MAITLAND CITY CLUB

BCA ASSESSMENT REPORT

Maitland City Club – 14 Arthur Street, Rutherford

Report Type: Development Application (DA)

Figure 1 - Travel Distances in the shade structure

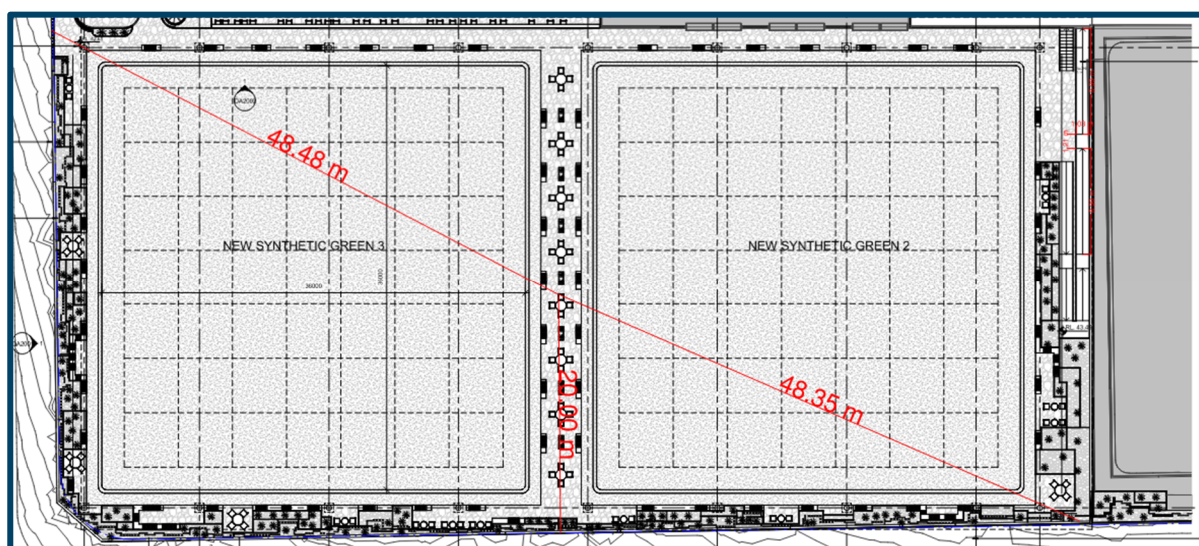
It will be necessary to undertake a Performance Solution to permit extended travel distances to an exit as per Clause D2D5 of the BCA. The Performance Solution must address the extended travel distances within the new function rooms and the covered shade structure. Further information will be required during the Construction Certificate Stage.

Furthermore, an additional Performance Solution will be required to permit the distance between alternative exits to be more than sixty (60) metres to an exit within the shade structure, including the existing Class 9b Club, as the alternative exit for the new function rooms relies on exiting back through the Club.

It is recommended that two (2) egress gates are included to permit occupants to discharge to the road. Further design input will be required during the Construction Certificate Stage.

Figure 2 - The Foyer Stair on the Lower Ground Floor

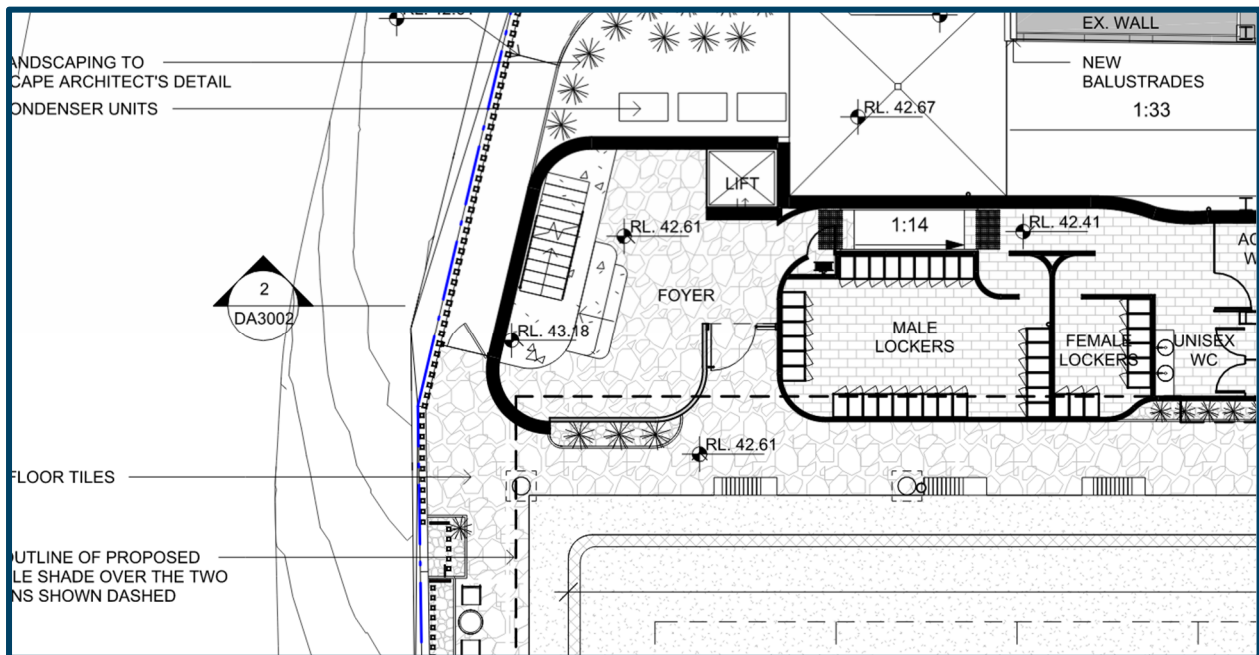
It is necessary to alter the stair design within the Foyer on the Lower Ground Level. The design's going and risers will need to be consistent to ensure a continuous handrail can be provided to at least one (1) side of the stair. Further design input will be required during the Construction Certificate Stage.

Figure 3 - The egress door to Woodberry Street

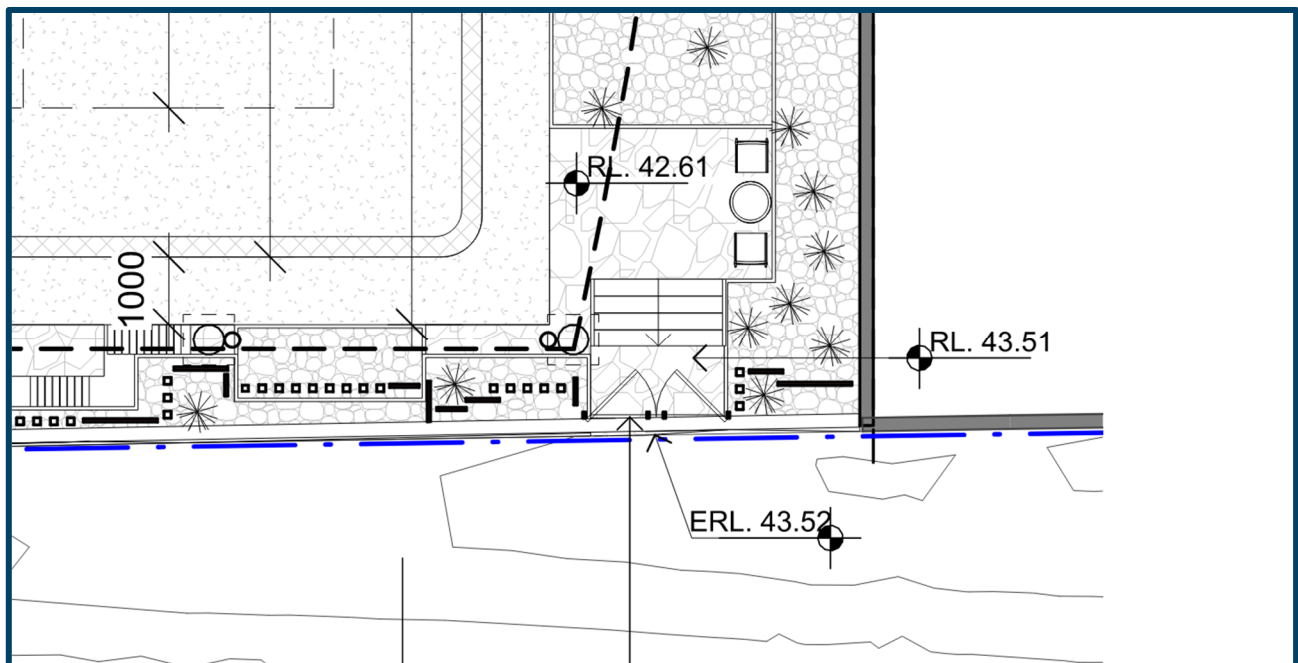
Furthermore, the egress doors within the Shade Structure are required to swing in the direction of egress as per D3D25.
